GE-MNGP-AEP-1913 R1

GEH Responses to Reactor Systems RAIs – Non-proprietary

Reactor Systems RAI-01

Figure RAI-02 2.16 Bundle Operating LHGR (kW/ft) at 12500 MWd/ST (peak MFLPD*)

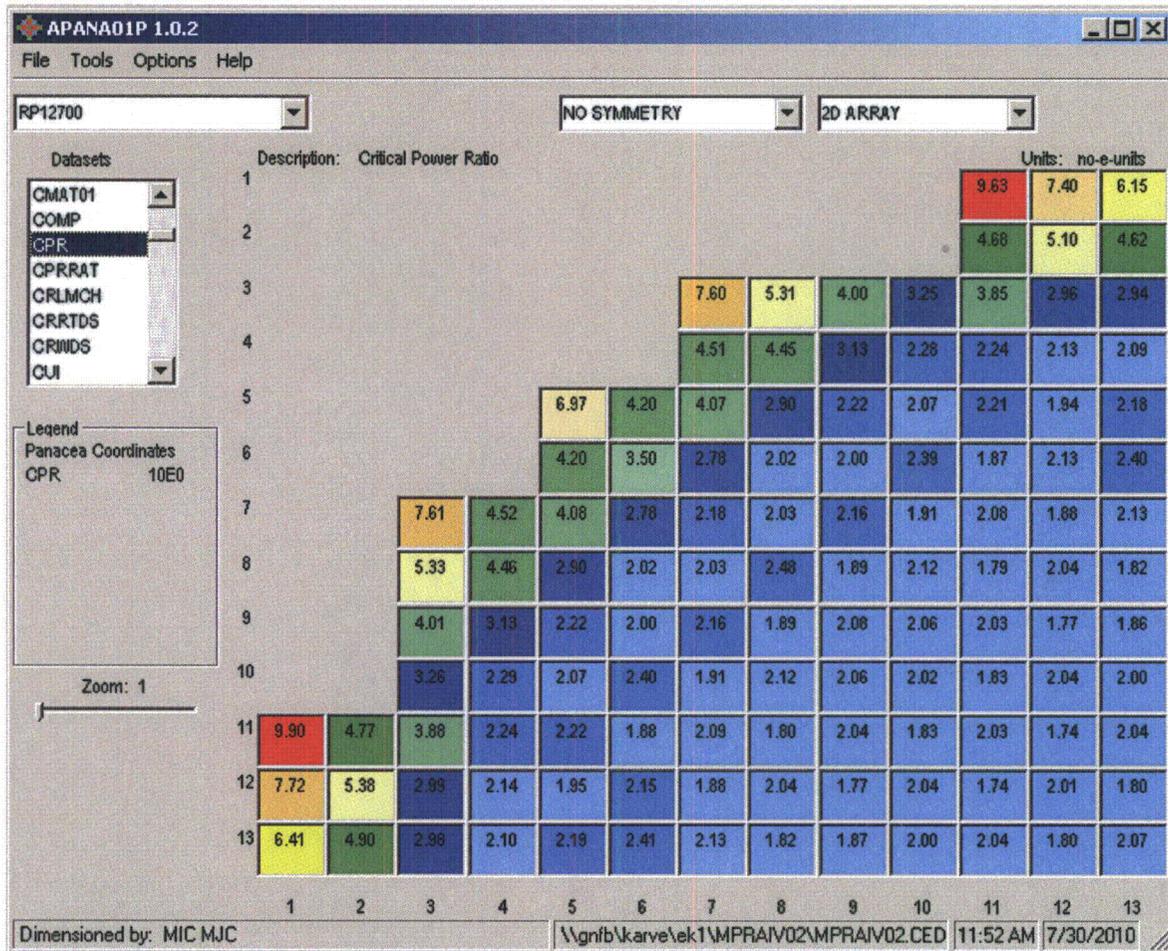
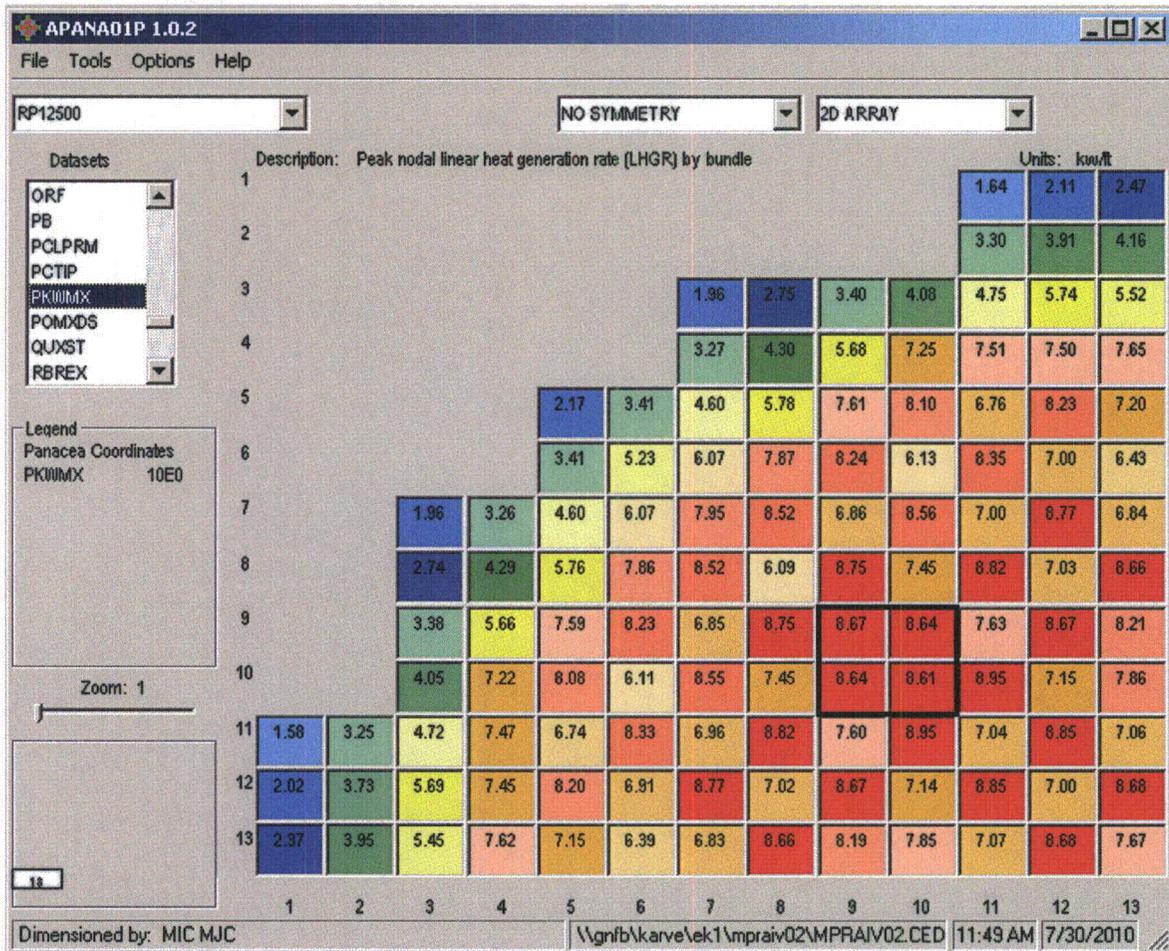
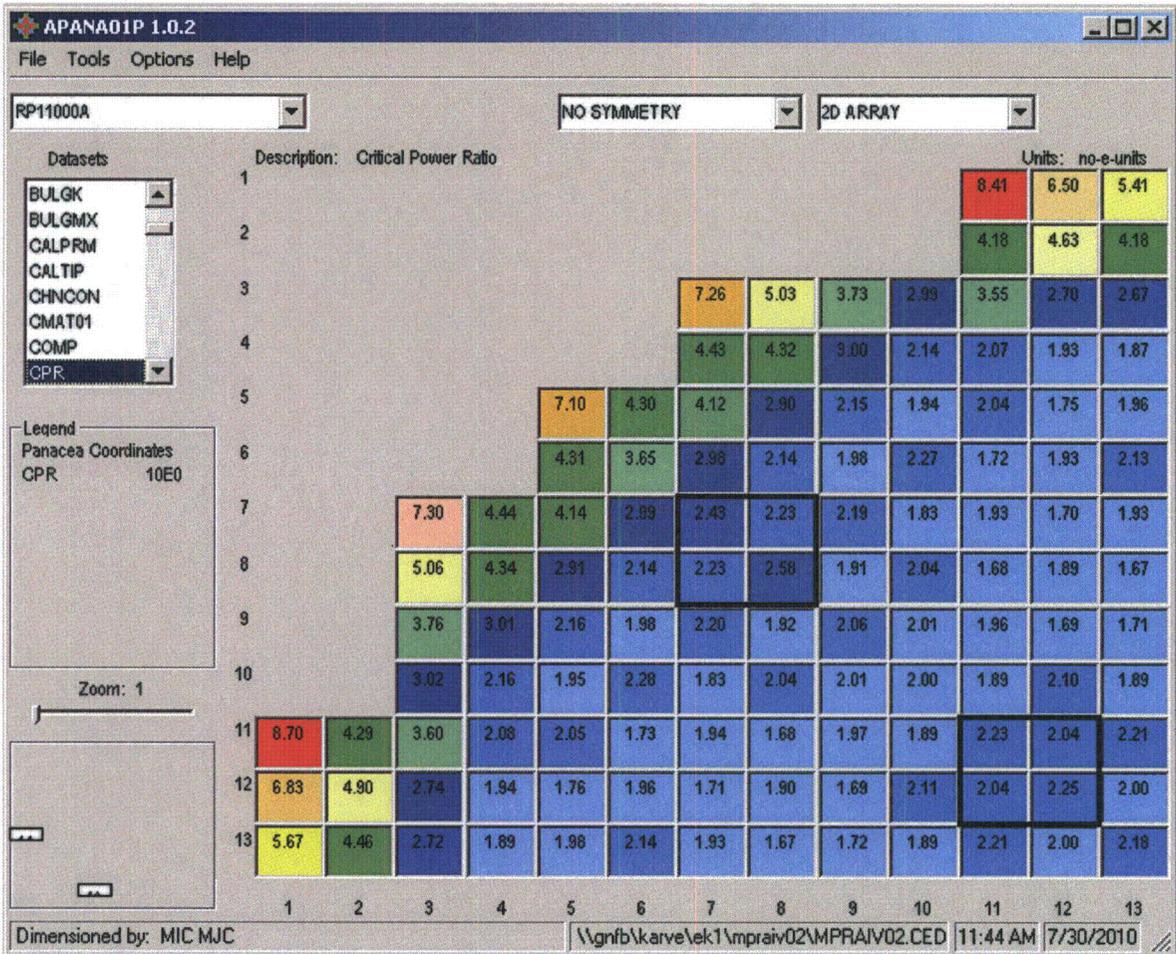
Section 2.1.2 of NEDC-33435P/Rev1 states that “Because there is no increase in the average bundle power or in the maximum allowable peak bundle power there is no change required to the fuel thermal monitoring threshold.” Figures 2-7 through 2-17 provide 2D bundle distributions for relevant parameters for the representative MELLLA+ core. Provide similar figures for the last non-MELLLA+ Monticello core.

As clarified and agreed on the phone call with the NRC on July 19, 2010, the following figures for the cycle 25 Extended Power Uprate (EPU) reload licensing core are “representative” of the last non-MELLLA+ Monticello core. The ¼ core maps are shown as Figures RAI-02 2-7 through 2-17 consistent with the figures (and figure numbers) in NEDC-33435P, Revision 1 (Reference RAI-02-1). The cycle 25 licensing calculations were performed at an EPU power of 2004 MWt and designed for nominal cycle energy of [[.....]]. The 200 MWd/ST cycle exposure represents the beginning-of-cycle (BOC) point, the 8,500 MWd/ST cycle exposure represents the middle-of-cycle (MOC) point, and the 12,700 MWd/ST cycle exposure represents the end-of-cycle (EOC) point. The peak Maximum Fraction of Limiting Critical Power Ratio (MFLCPR) point is at a cycle exposure of 11,000 MWd/ST and the peak Maximum Fraction of Limiting Power Density (MFLPD) point is at a cycle exposure of 12,500 MWd/ST. All points are adjusted to be at the 100% EPU power level. The flows at the BOC, MOC, peak MFLCPR, and MFLPD points are adjusted to the 99% rated flow and the EOC point is adjusted to the 105% rated flow. The EOC point is an all rods out condition.

Heat Capacity Temperature Limit (HCTL)

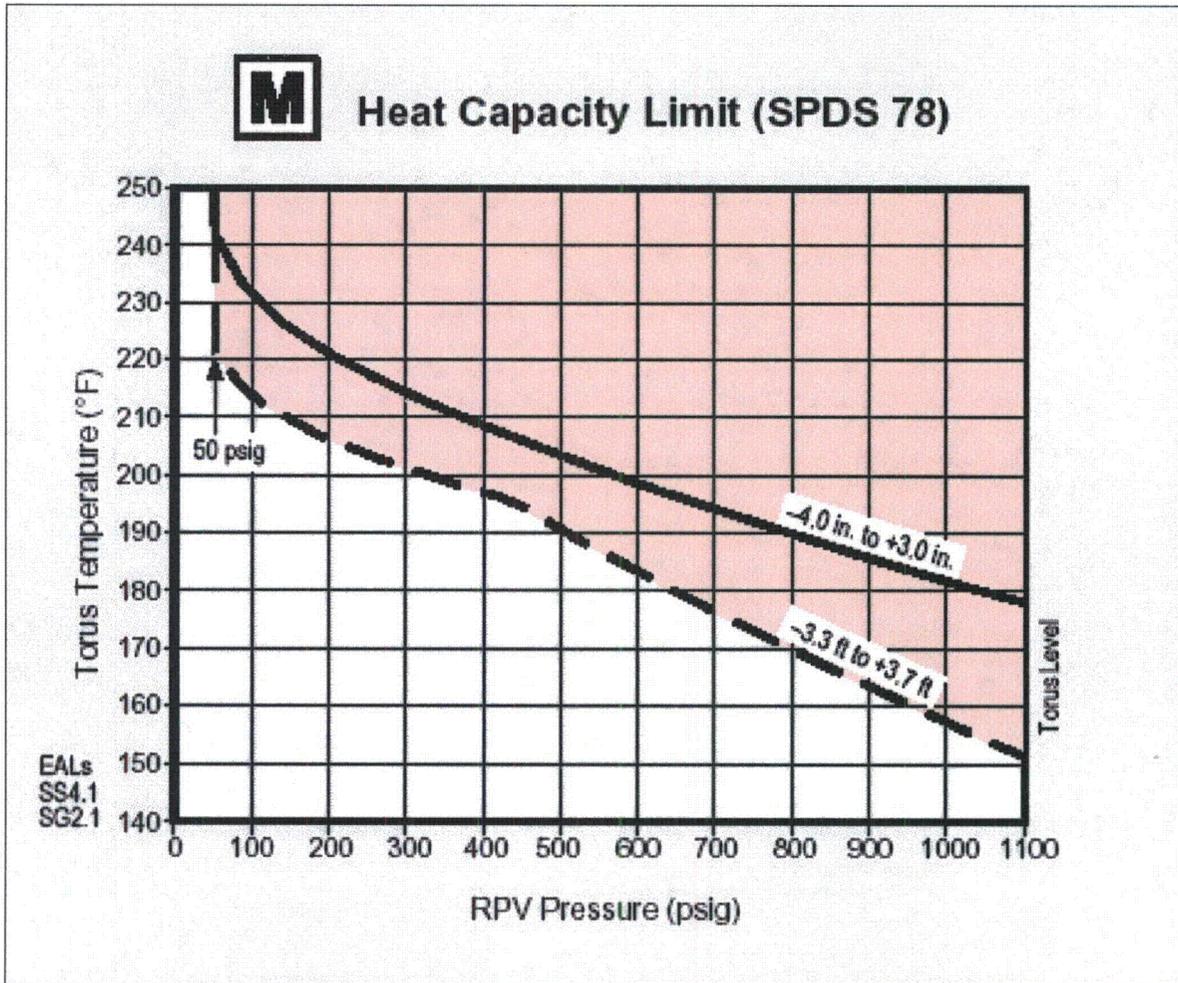
For the licensing ODYN ATWS analysis and the best estimate TRACG analysis described in Section 9.3 of NEDC-33435P/Rev1, provide time traces and tabulated values for reactor power, pressure, peak PCT, and suppression pool temperature. Provide the HCTL as function of reactor pressure and the HSBW injection time.

The HCTL as a function of reactor pressure is provided below.

Reference: Monticello Nuclear Generating Plant EOP C.5-1200 Revision 16.

It is noted that the curve provided above changes by a small amount with EPU. However, the sensitivities on different HCTLs (175°F vs. 150°F) and water level strategies (TAF vs. TAF-2ft) were performed to evaluate the possible range of conditions at Monticello.
